## Japan's Comment on Injury Criteria for Amendment of R94

A: Difference of the target age between the offset test and full width test

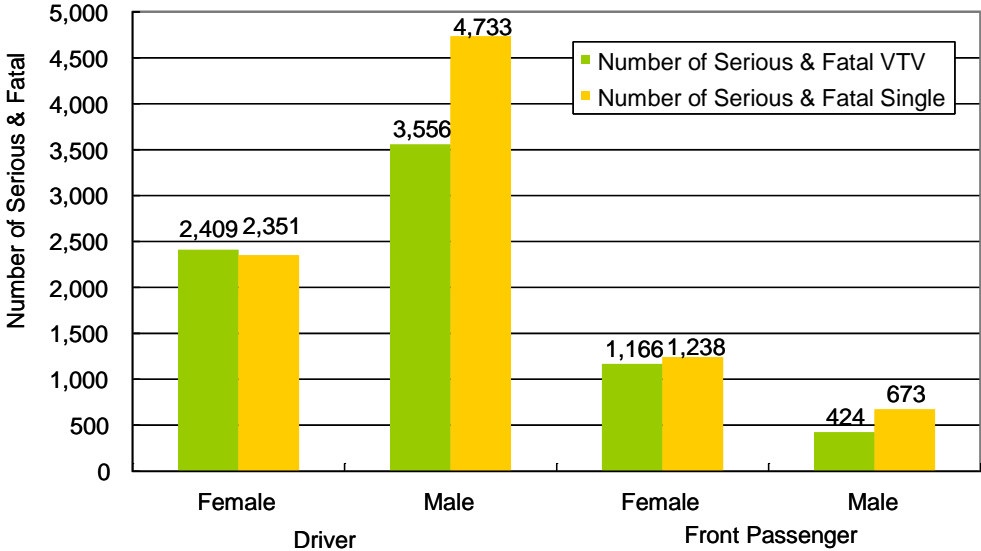
B: Difference of the gender of the passenger dummy between the offset test and full width test

On the other hand, there are no data showing any difference in the age composition or gender ratio of occupants due to the difference of crash configuration between the full width test and offset test. Hence, we do not see any justification for those age and

gender differences between the two tests and would like the reason(s) for requiring the different dummy conditions for ODB and FWRB to be clarified. We consider the reasons must be known in order for the Regulation to be widely adopted throughout the world as a truly international regulation.

Numbers of Serious Injuries and Deaths by Gender  
on the Driver's Side and Front Passenger's Side

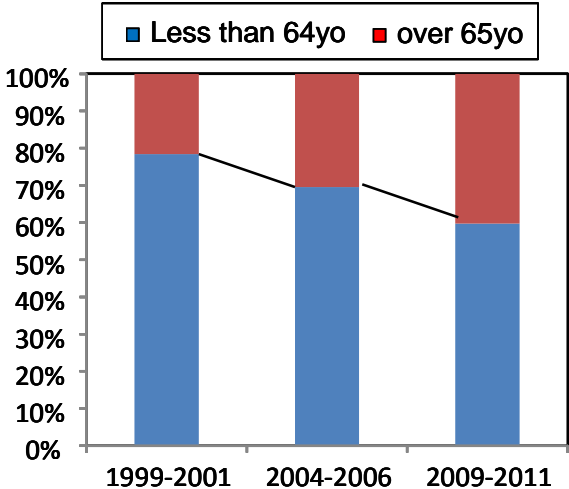
More male occupants are seriously injured or killed on the driver's side and more female occupants on the front passenger's side.

Changes in Composition of numbers of Deaths  
by Age of the Occupant in the Driver's Seat

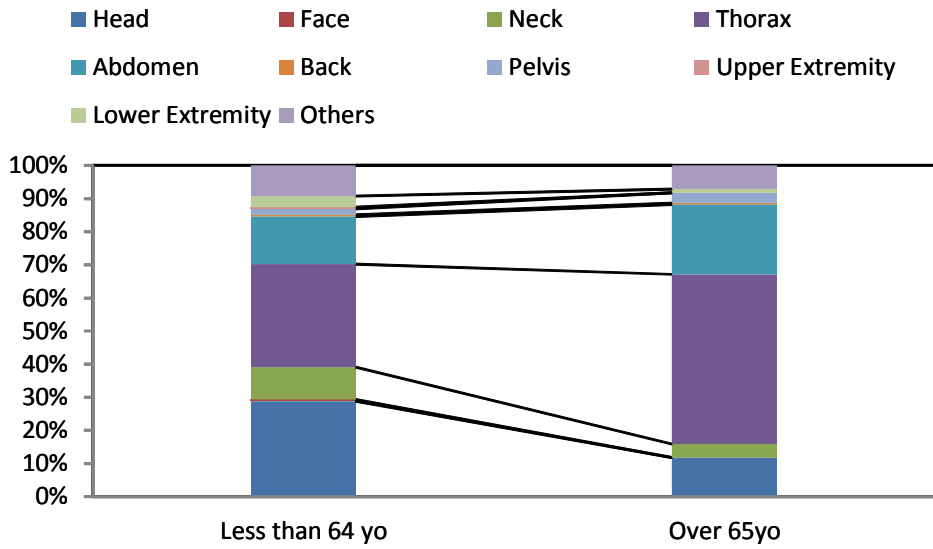
The percentages of deaths of elderly occupants have increased.
